REV.
B

AS1895™/16

RATIONALE

FLANGE, MALE, INTEGRAL, WELD RING,
TYPE II LOW PROFILE

FIGURE 1 - TYPICAL SECTION

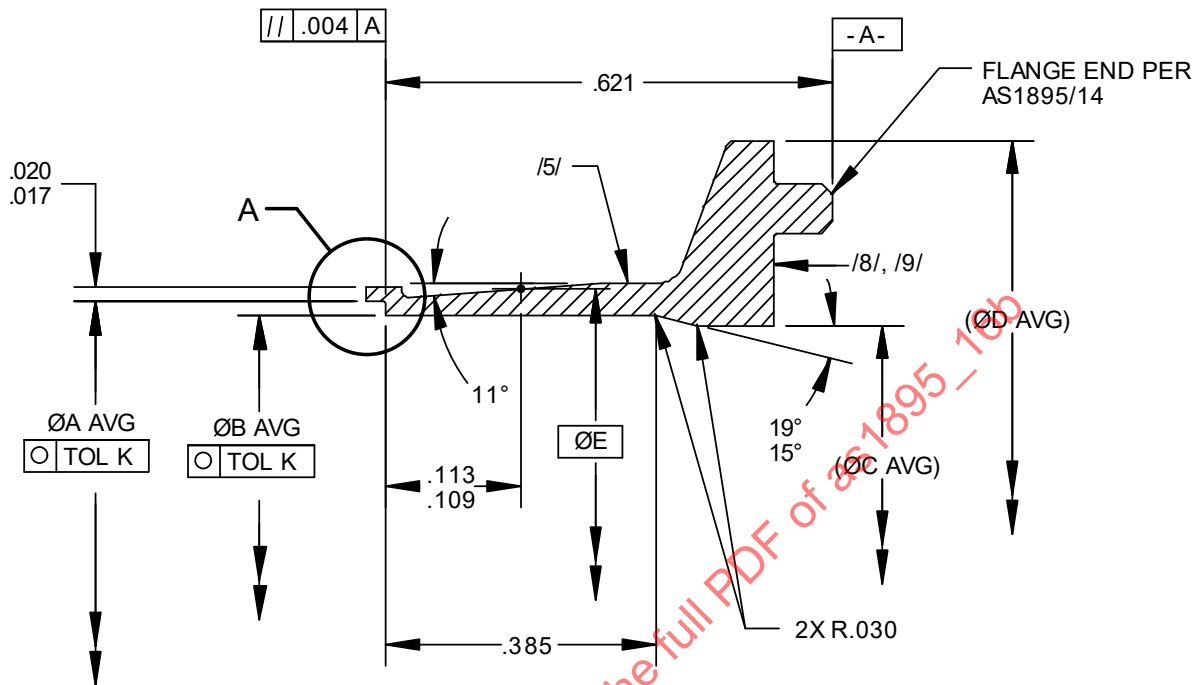
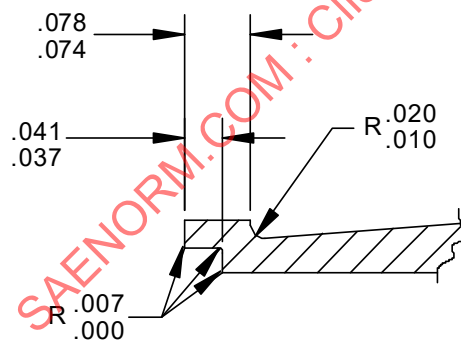
GRAPHICS REDRAWN. PERPENDICULARITY REQUIREMENT REMOVED FROM REFERENCE ØC. TABLE 1 REDRAWN TO ADD "REF" TO DIM C AND D. TOLERANCE FOR DIM "B" REVISED. NOTE 3 REVISED TO STATE CURRENT QML NOTE. GENERAL UPDATING OF SPECIFICATIONS BEING SPECIFIED HEREIN. CHANGE BAR NOTE REVISED. NOTE 17 ADDED.
